ADDENDUM NO. 2 TO BID NO. 16-0092-4

FOR: CHATHAM COUNTY DETENTION CENTER EXPANSION - PROJECT 2

**SECTION 00 9112**  
**ADDENDUM NUMBER 2**

**PROJECT: CHATHAM COUNTY DETENTION CENTER EXPANSION PROJECT 2**

DW/CK:  
DMK / RV  
SCALE:  
AS NOTED

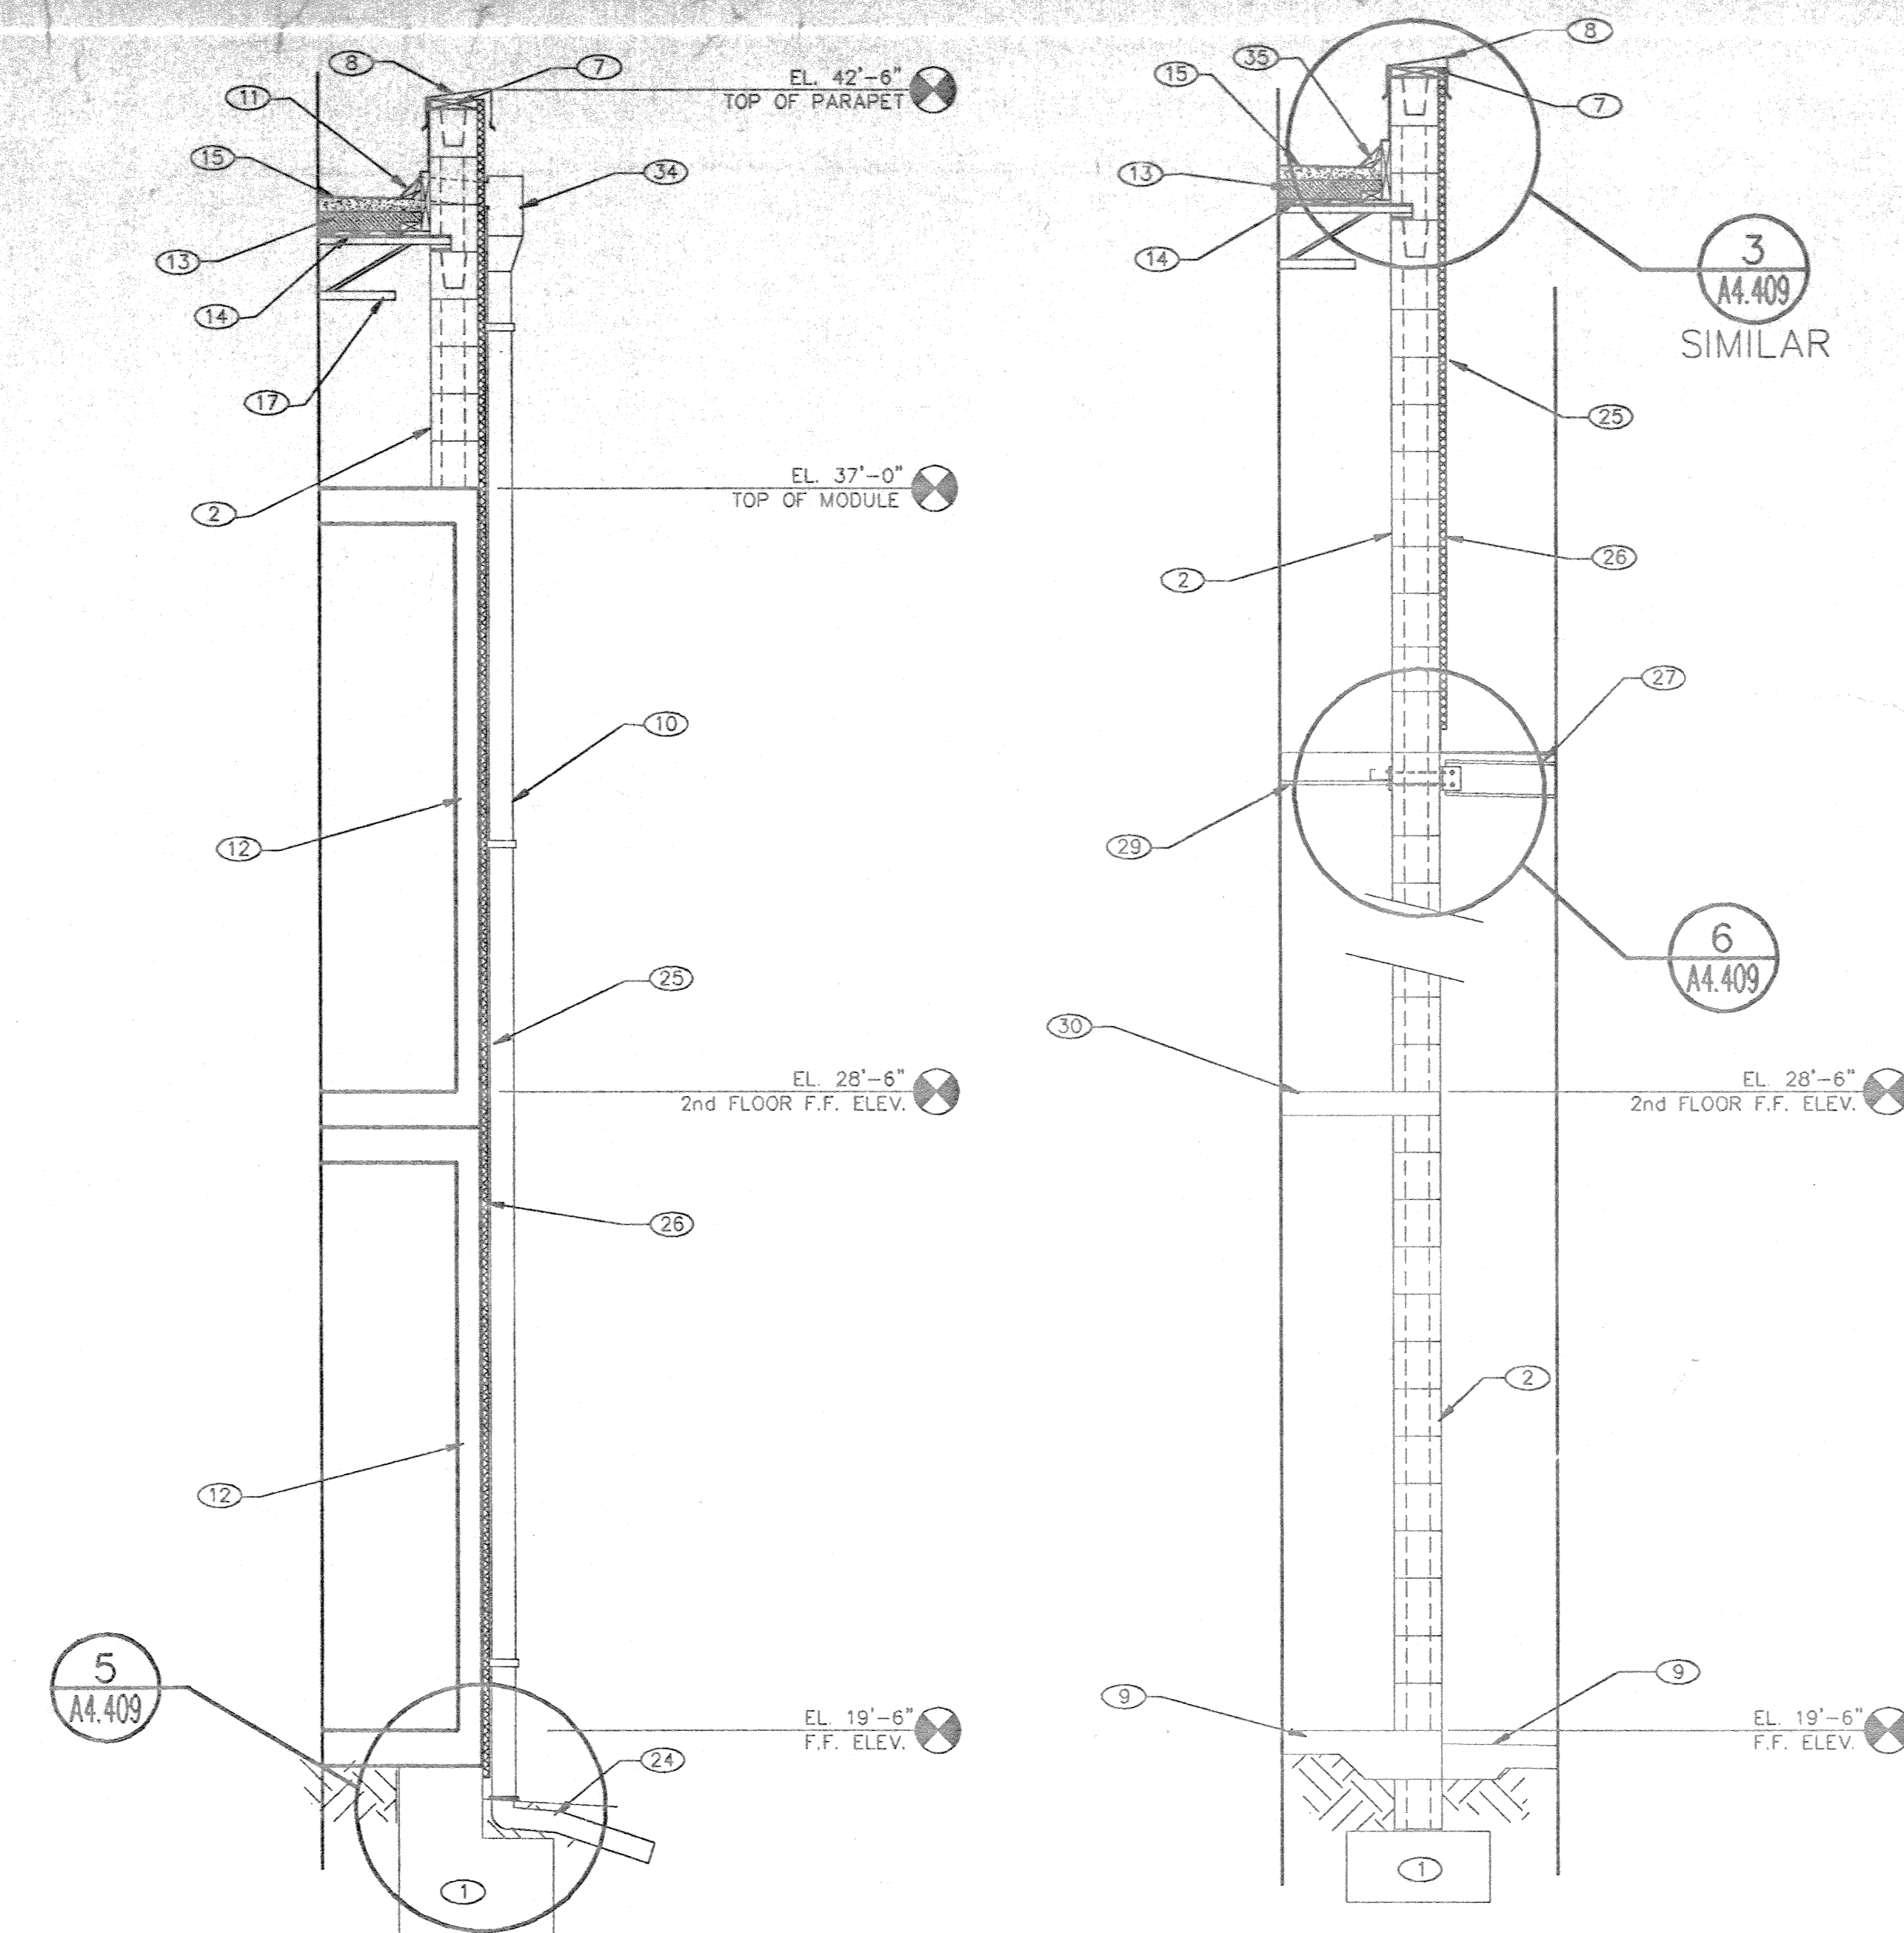
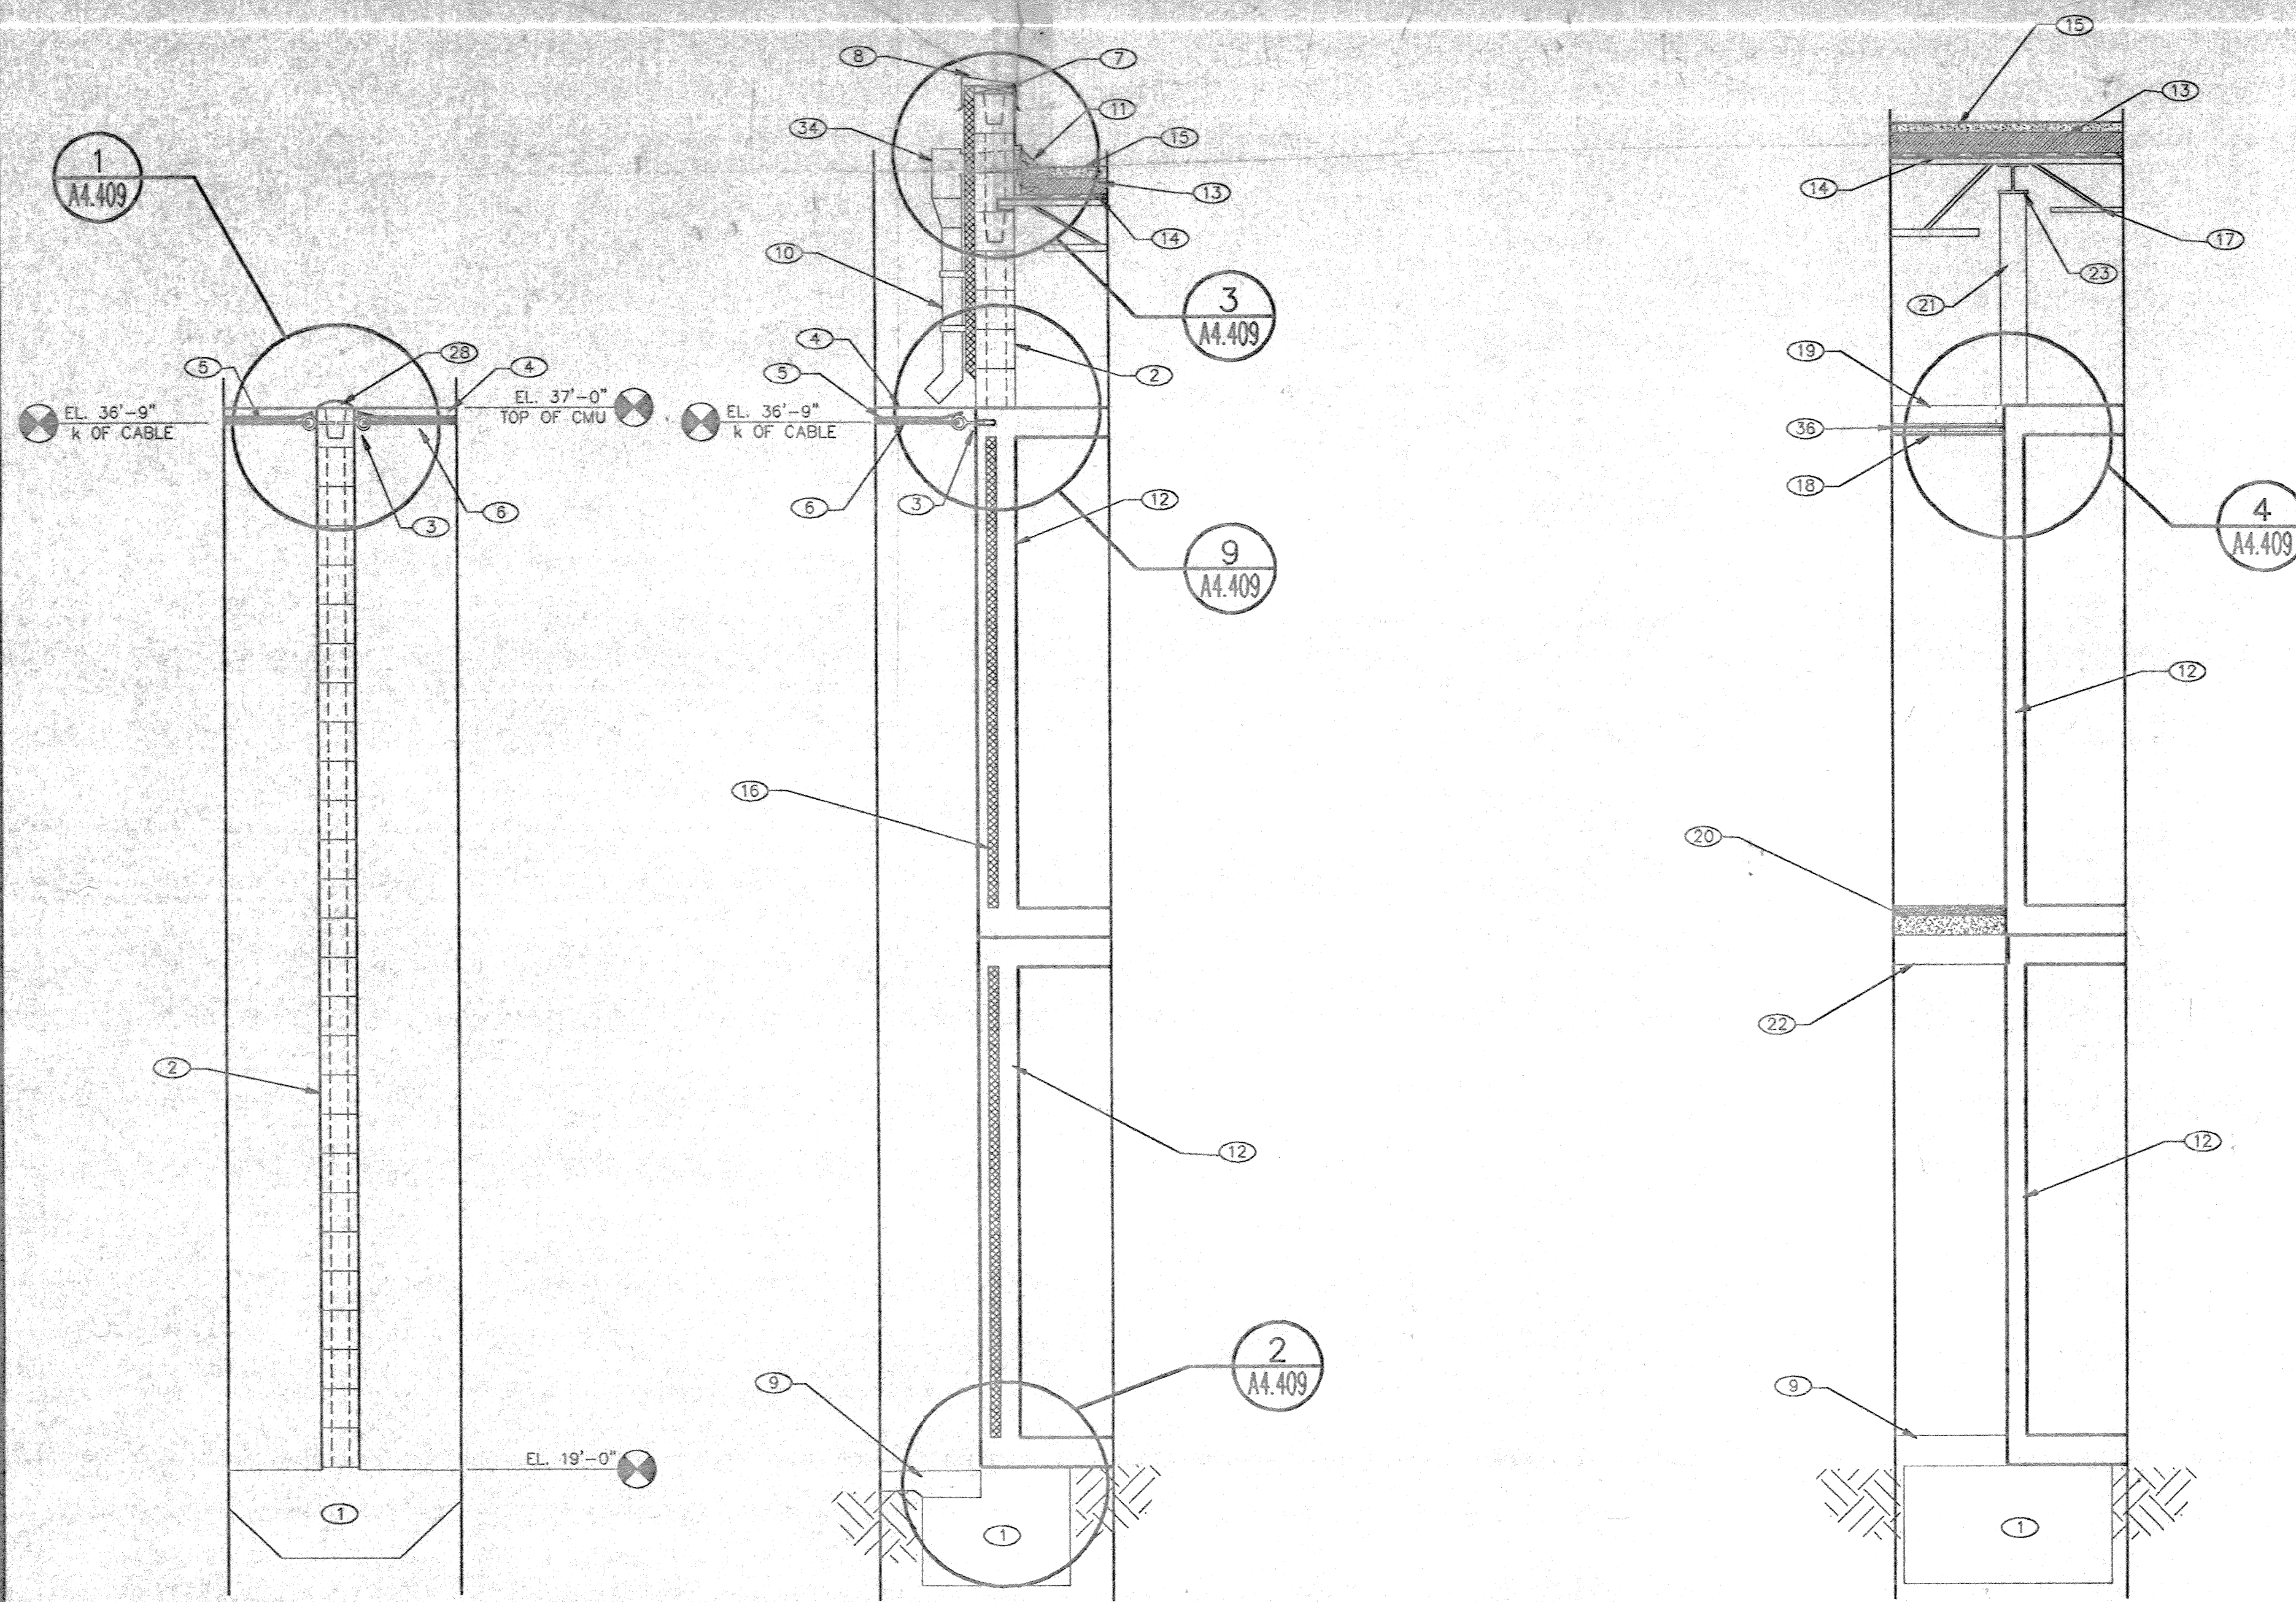
Item #08. Revise Drawing according to Supplemental Drawing SD-A202 issued with this addendum.
